**Part Number Affected:** 726-3046 Ratchet Fastener

**Models Affected:** All Twin and Triple Baggers On All Platforms.

**Subject:** Replacement Of 726-3046 Ratchet Fastener On Bagger

**FIGURE 1**

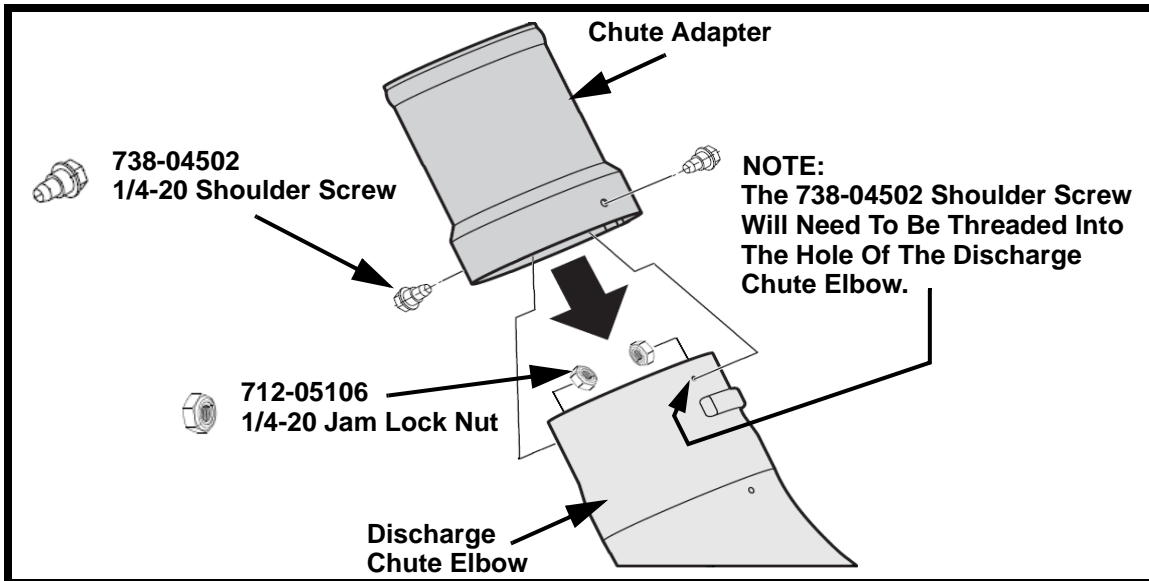
We have received reports that the **726-3046** ratchet fastener may become loose and fall out. This can cause the upper chute assembly to become disconnected from the discharge chute elbow.

- Qty. (2) **738-04502** Shoulder Screw 1/4-20
- Qty. (2) **712-05106** Jam Lock Nut 1/4-20

2. Install the **738-04502** 1/4-20 shoulder screws from the outside of the chute adapter and securely tighten with the **712-05106** 1/4-20 jam lock nuts on the inside of the discharge chute elbow. See Figure 1.
